**HUMMINGBIRD PARK
 (PN: LW56)**

**HUMMINGBIRD PARK (PN: LW56)
(Addendum #2)**

ADDENDUM NO. 2

Hummingbird Park
P.N.: LW56

11
L-9

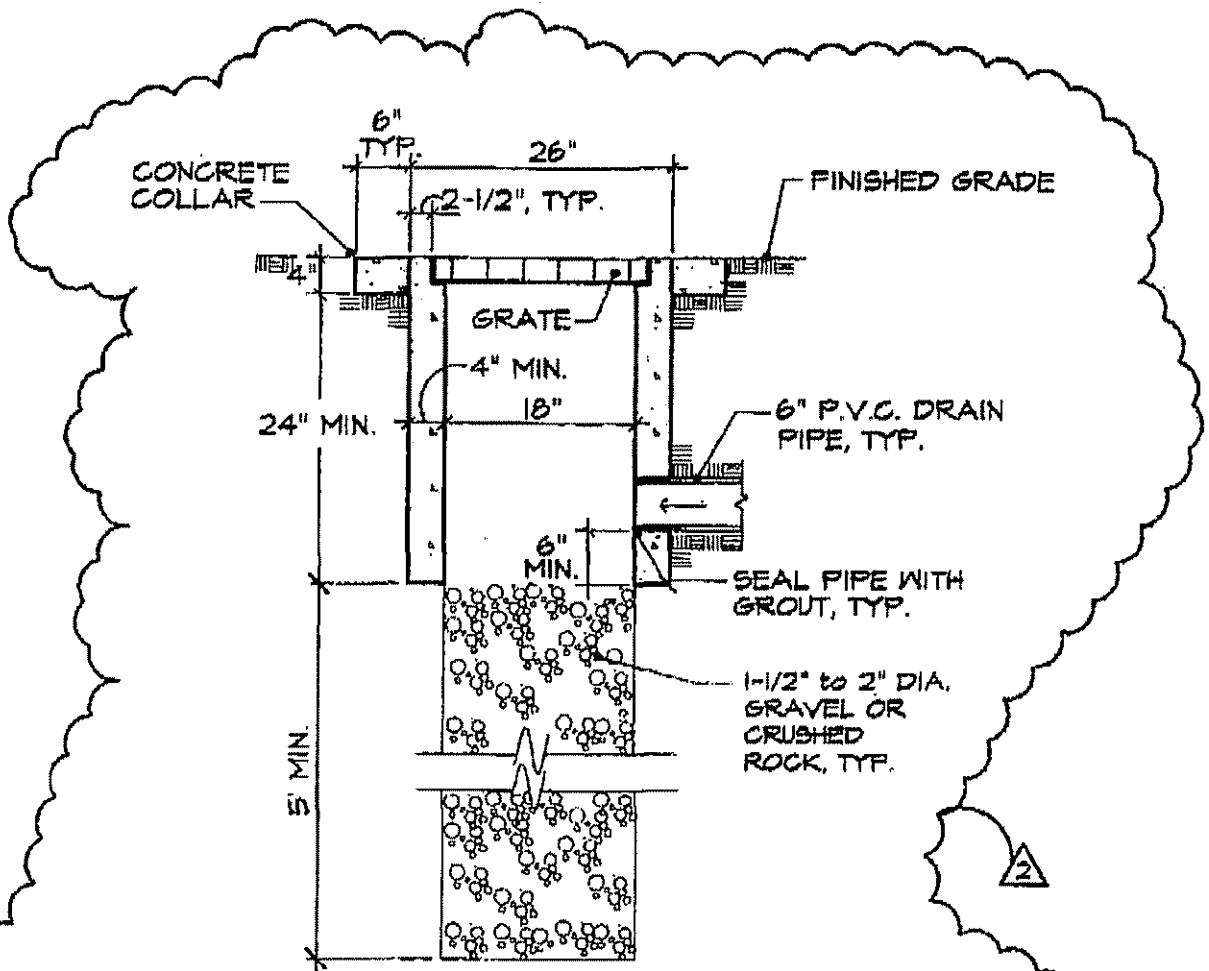
1. CATCH BASIN INSIDE DIMENSIONS ARE 18" X 18".
2. GRATE DIMENSIONS ARE 20 1/2" X 20 1/2". GRATE HEAVY DUTY CAST IRON, OR APPROVED EQUAL.
3. CATCH BASIN MAY BE POURED IN PLACE OR PREGAST.
4. 6" CONCRETE COLLAR SURROUNDS CATCH BASIN.
5. GROUT SHALL BE NON-SHRINK EPOXY GROUT, MEADOWS "SEAL-TIGHT", OR APPROVED EQUAL.

1. revision: **Sheet L-9, Construction Details:** revise Drinking Fountain w. Jug Filler Detail 9/L-9. See attached 8-1/2 x 11 exhibit.
2. add: **Sheet L-9, Construction Details:** add Drinking Fountain Catch Basin Detail 11/L-9. See attached 8-1/2 x 11 exhibit.
3. clarify: **Sheet L-4, Layout Plan, Notes & Legend:** The 0 YD, 100 YD, 200 YD, 250 YD brass markers area as indicated on the center line of the concrete pathway as shown on the Layout Plan on Sheet L-4.
